Product Change Notice

Date:	September 17, 2019
Overview:	A change has been made to the terminal box for 94 frame AC motors
Reason for Change:	Improved design due to updated tooling
Affected Part No(s):	Ø400 mm radial fans and Ø400 to Ø500 mm axial fans using an AC motor (1-phase / 3-phase) in size 94 (exact PNs listed on last page of this notice)
Design Change Detail:	The new terminal boxes are more robust and have an improved sealing system - the bottom part of the terminal box now has integrated sealing which eliminates the need for an O-ring. The overall height of the terminal box remains the same.
Effective Date:	Running change, effective immediately
Last Time Buy Deadline:	N/A
Pricing:	No change
ebm-papst employee:	Jeannine Zenobi
Attachments:	<ul style="list-style-type: none"> Detailed comparisons, original vs new design List of specific PNs affected by this change
Comments:	110 and 138 frame motors are also impacted (please see separate PCNs)

AC Motor Size 94

Original Terminal Box

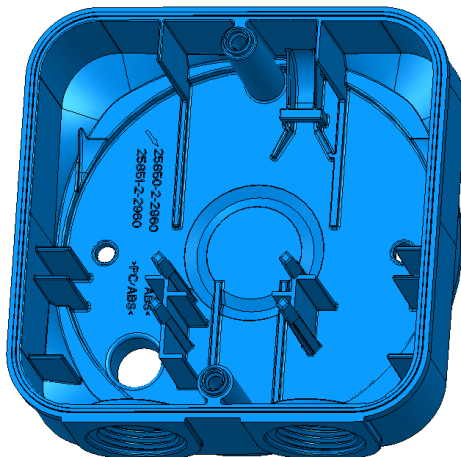
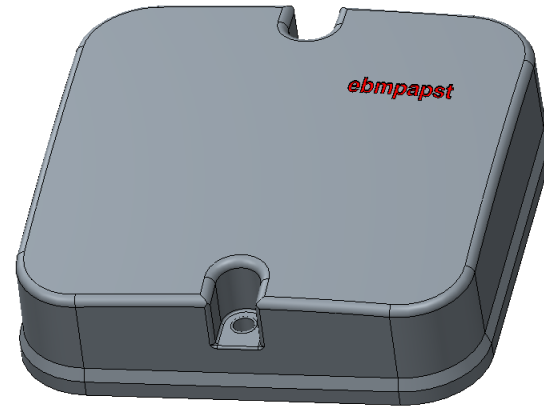
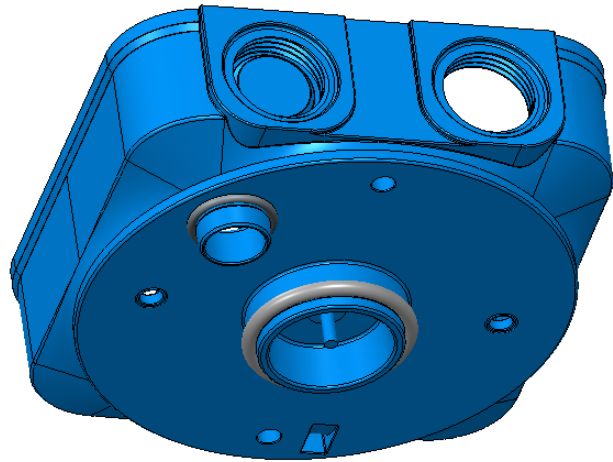
Terminal Box Comparisons

Original Terminal Box

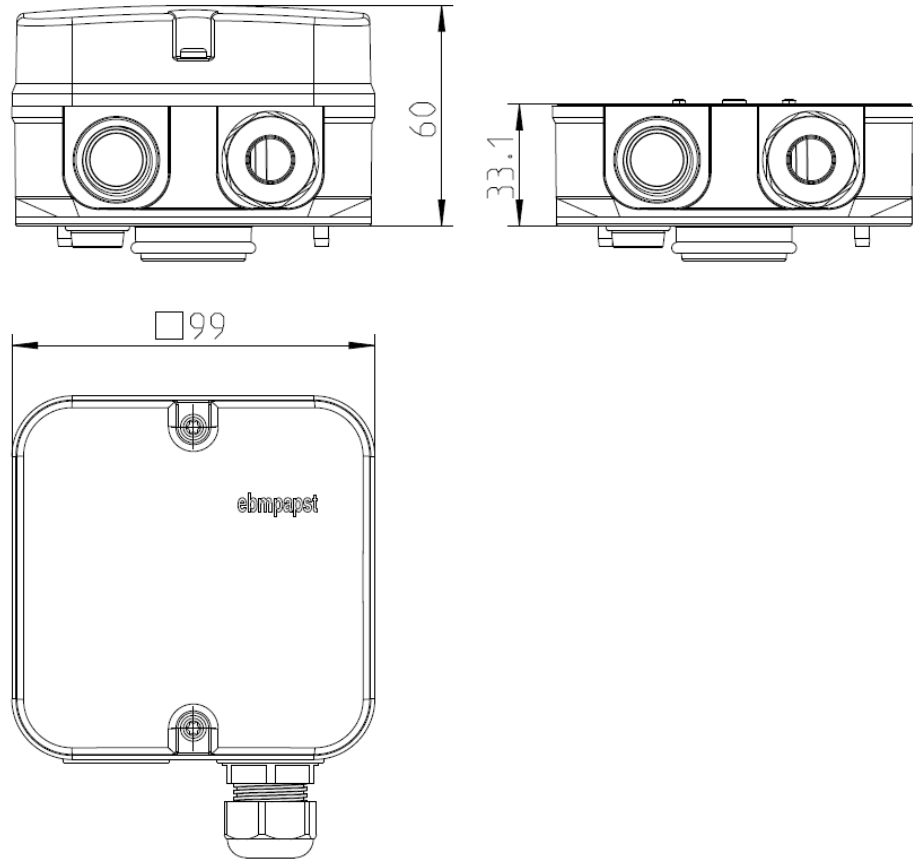
Measurements

Original

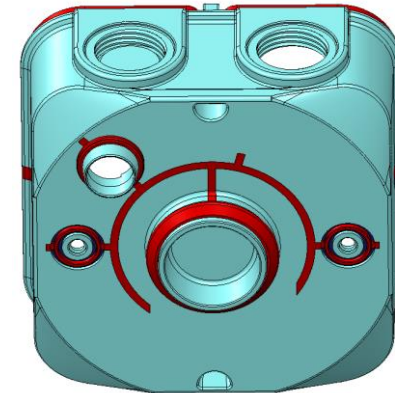
Improved sealing system

O-rings

Sealing in terminal box
(cover)

New

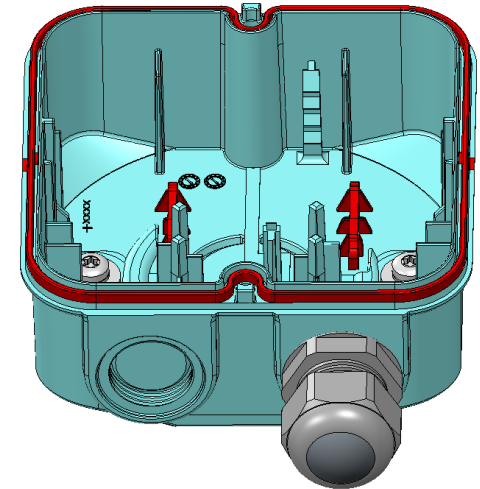
2K-sealing
(similar to sizes 110 and 138)

Improved sealing
(bottom)

Cable tie

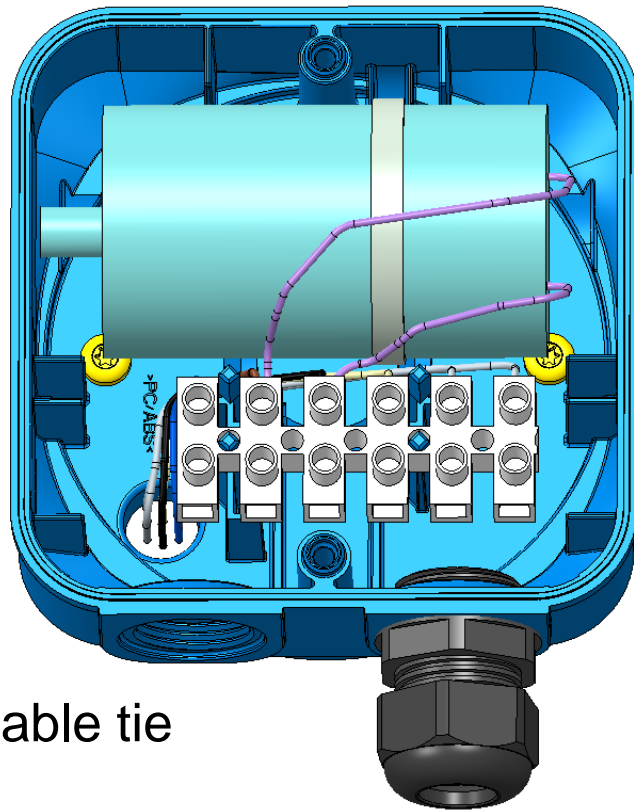
Capacitor fixation inside bottom of terminal box (1~ fans)
